| **Newsletter** | **ENL-19-016-SR Revision_IO** |
| **Model** | **L200 / Triton (KK0T, KL0T)** |
| **Subject** | **Side Step Shade drop-off due to rivet fracture** |
| **Revision** | **Inspection code added** |

## 1. CONDITION:

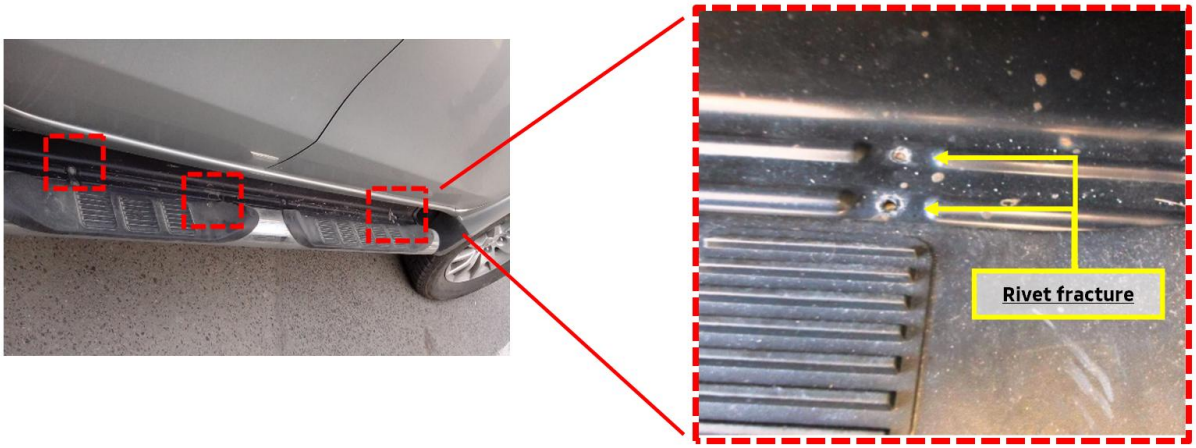
The rivets fixing the side step shades may corrode and fracture. In case all the rivets fracture, the side step shades may drop off from the vehicle causing a risk of a vehicle accident.

## 2. CAUSE:

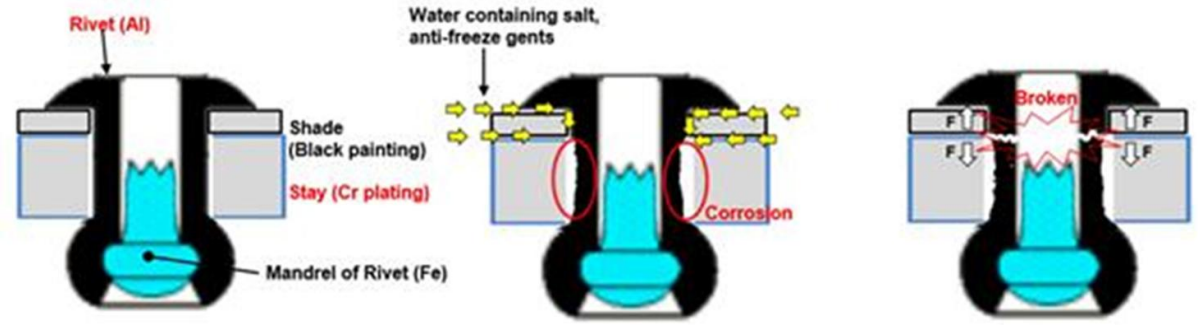
The rivets corrode and fracture especially under the environmental usage condition where these are exposed to salt or anti-freeze agent.

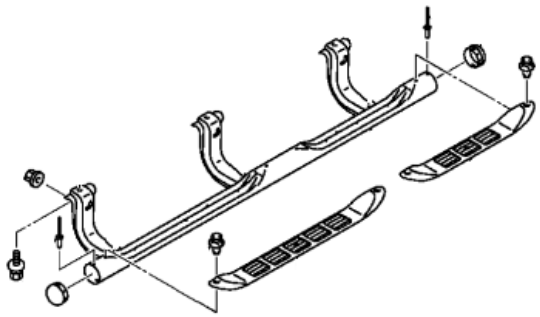
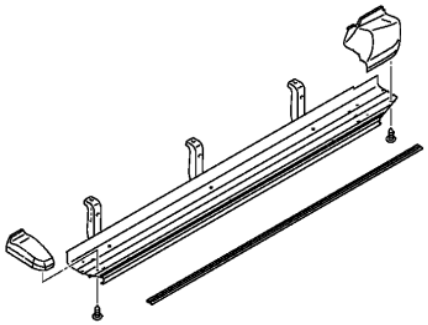
Inspect whether the original pipe type side steps are installed before continuing to the repair procedure.

Original pipe type

Plate type since 17MY

Remove all the rivets and fix the side step shades with new bolts and nuts instead.
Refer to the attached repair procedure.
